# United States Department of the Interior

January 20, 2012

Reference is made to the following plan:

Control No.	S-07437
Type	Supplemental Development Operations Coordination Document
Received	September 23, 2010, amended October 14, 15, 18, 19 and 21, November 1 and 9, 2010, January 11 and 25, February 3, 14 and 15, April 12 and 26, May 12, June 2, 3 and 9, August 2, November 9 and 17, 2011
Lease(s)	OCS-G 14016, Block 711, Mississippi Canyon Area

### SEAFLOOR AND SUBSURFACE FEATURES MAP SITE CLEARANCE of PROPOSED WELL NOS. 9, 10 and 11 BLOCKS 710 & 711 MISSISSIPPI CANYON AREA

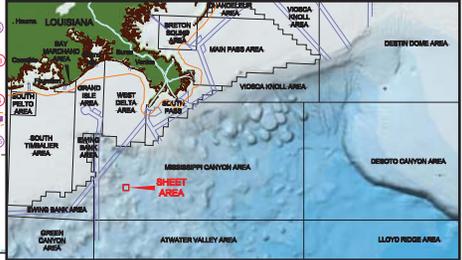
Our review indicates that your proposed activities are in the vicinity of areas that could support high-density chemosynthetic communities. Use a state-of-the-art positioning system (e.g., differential global positioning system) on your anchor handling vessel to ensure that any seafloor disturbance resulting from your use of anchors (including that caused by the anchors, anchor chains, and wire ropes) does not occur within 250 feet of such areas (see enclosed Seafloor and Subsurface Features Map Site Clearance of Proposed Well Nos. 9, 10, and 11 submitted with an amendment to your plan, which depicts the areas). Submit plats for Wells 9 and 10, which depict the "as-placed" location of all anchors and any associated anchor chains and wire ropes on the seafloor, at a scale of 1 inch = 1,000 feet with DGPS accuracy, to the Regional Supervisor, BOEM, Leasing and Plans (MS 5231) at the same time you submit your End of Operations report (Form MMS-125) to the appropriate BESE GOMR District Office, to demonstrate that the features were not physically impacted by these anchoring activities.

Exercise caution while drilling due to indications of shallow gas and possible water flow.

Our review indicates that there are pipelines in the vicinity of Subsea Wells 9, 10, and 11 that may pose a hazard to your proposed operations. Therefore, take precautions in accordance with Notice to Lessees and Operators No. 2008-G05, Section VI.B, prior to performing operations.
